# Wisconsin Department of Transportation

### NOTICE TO ALL CONTRACTORS:

**Proposal #12: 8010-00-70, WISC 2020 286**  
**Village of Superior, Tower Avenue**  
**69<sup>th</sup> Street to 64<sup>th</sup> Street**  
**STH 35**  
**Douglas County**

This is Addendum No. 01, which provides for the following:

Addendum No. 01  
ID 8010-00-70  
Revised Sheet 5  
July 8, 2020

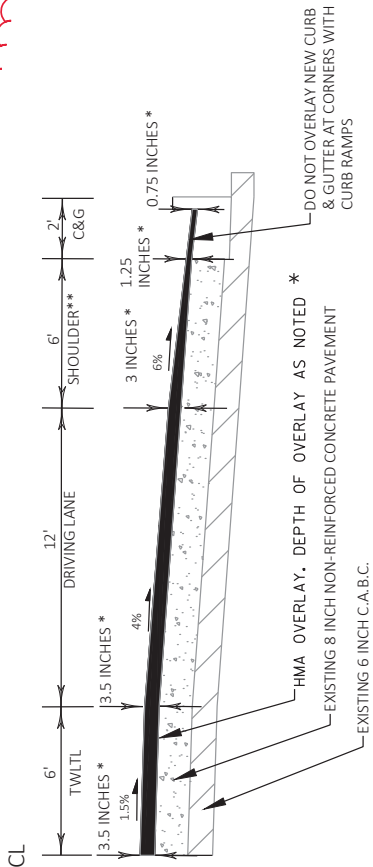
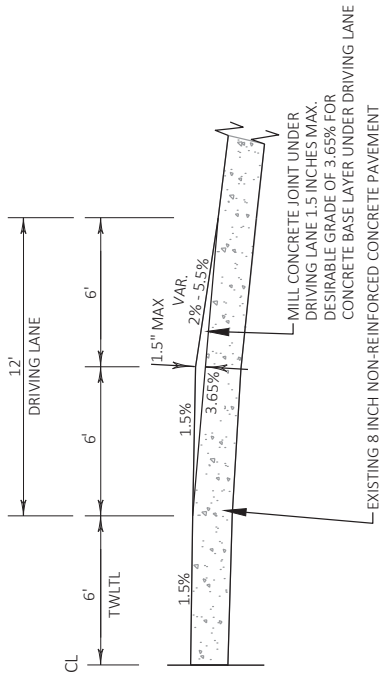
Revised Plan Sheets	
Plan Sheet	Plan Sheet Title (brief description of changes to sheet)
5	Typical Sections – Hma Overlay Detail And Notes
38	Miscellaneous Quantities – Addition Of Item 305.0500 Shaping Shoulders

\*\* INCENTIVE DENSITY HMA PAVEMENT ITEM ONLY APPLIES TO TWLTL AND DRIVING LANES.  
\*\* URBAN SHOULDER DOES NOT MEET MINIMUM THICKNESS PER HMA SPECIFICATION.
